# MEMORANDUM

**HEARING:** Malvern Rezoning Requests

**PREPARED BY:** Jon Trewin – Policy Planner

# Bond, Bridge Street, Coalgate: ODP and Narrative

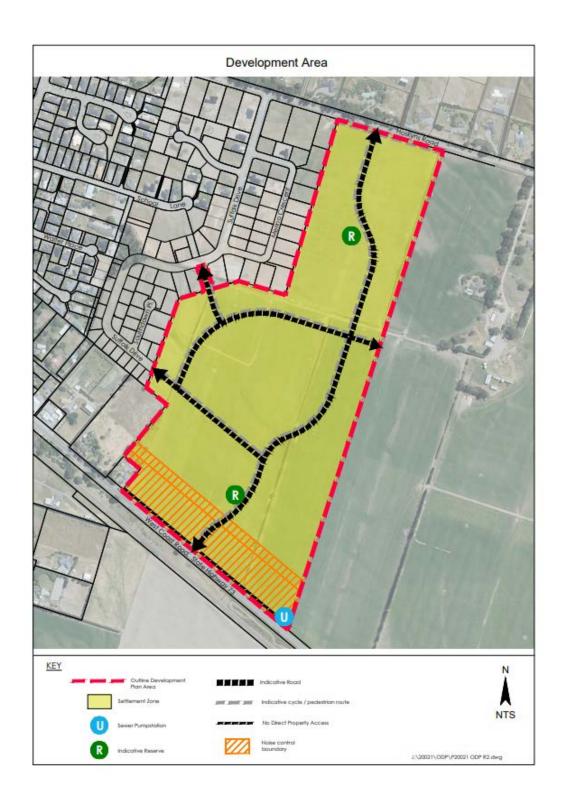
- 4.2.2. Primary access should be on Bridge Street and an indicative pedestrian link should be shown on an outline development plan (ODP). Bridge Street is a more appropriate access point than SH77 to the north and given the road speeds of Bridge Street currently outside of the site (being a maximum of 100km/hr), the access point will need to be appropriately located away from the SH77/Bridge Street intersection. The submitter agrees to this and an ODP is included with these features (see below).

- 4.2.3. Confirmation that there are not likely to be any geotechnical or site contamination issues as this was unclear from the initial evidence provided. *Mr Johnson comments that reports addressing these issues will be made available before the Hearing. A Preliminary Site Assessment (PSI) and Geotechnical report were provided on 3<sup>rd</sup> April 2023. Due to the timing, it has not been possible to have these reports peer reviewed. The PSI report concludes that no issues have been identified on the site that preclude future residential development. The Geotechnical report makes a similar finding, that residential development can be accommodated providing the appropriate inspection and design of foundations in accordance with the relevant Codes of Practice and the Geotechnical report.*

The Site will be accessed from Bridge Street. No access is to be provided to the State Highway on Homebush Road.

Provision is made for an extension of the footpath near the Tavern to the access in to the site.

Amended ODP, provided in rebuttal evidence supplied by Julie Comfort.

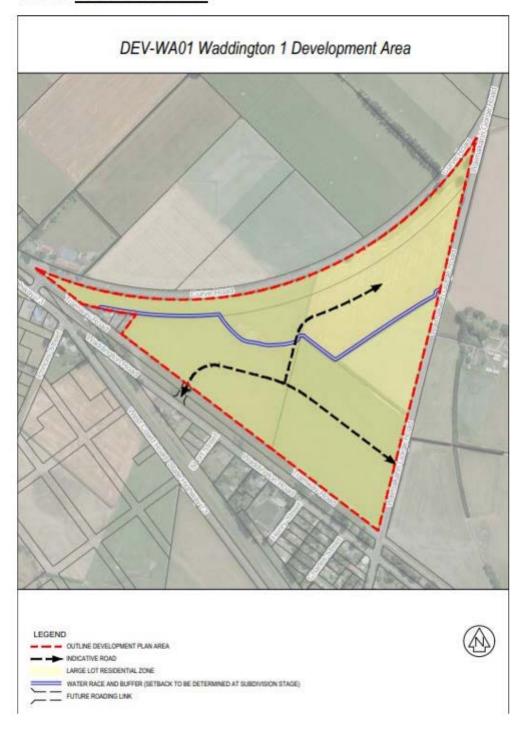
- 7.2.2. In addition, rebuttal evidence was provided by Mr de Verteuil that addressed points raised by Council's transport peer review by Mat Collins. Mr Collins has responded (**Appendix 4**):

- 7.2.2.1. Mr de Verteuil disagrees with the need to provide walking and cycling facilities on SH73 and disagrees with providing a shared use path on Hoskyn's Road. Mr Collins, on reflection, states that he considers Mr de Verteuil's concerns regarding the need for pedestrian and cyclist facilities on SH73 are valid as the current property boundary of 2490 West Coast Road would likely prevent any connection to the existing footpath further west. He recommends that the ODP narrative identify that the submitter should consider walking and cycling facilities on SH73 during subdivision, in consultation with Waka Kotahi.

- 7.2.2.2. Mr Collins though does maintain the need for a shared path along the site frontage at Hoskyn's Road to future proof a possible future cycleway link between Darfield and West Melton.

- 7.2.2.3. Mr Collins agrees with Mr de Vertuil's response to Waka Kotahi's submission that the submitter will be required to develop an appropriate design for any new intersection with SH73, in consultation with Waka Kotahi. He considers this can be addressed at the time of subdivision.

- 7.1. Rebuttal evidence has been provided by Bealey Developments Limited<sup>11</sup>. The rebuttal evidence relates to transport and planning (which also covers servicing and natural hazards issues).
- 7.2. In the S42a report, I recommended that in overall terms the submission be accepted subject to the following matters being addressed (listed below). How these matters have been addressed by the submitter through rebuttal evidence is included alongside the below points in *italics*:
  - 7.2.1. The ODP being amended to show walking and cycling connections internally and to the rest of Kirwee township and the presence of a noise control overlay from SH73. *In the rebuttal evidence provided by Julie Comfort, a revised ODP has been provided that shows walking and cycling connections, revised roading connections and both the noise control overlay boundaries for SH73 and the Rail Line.*
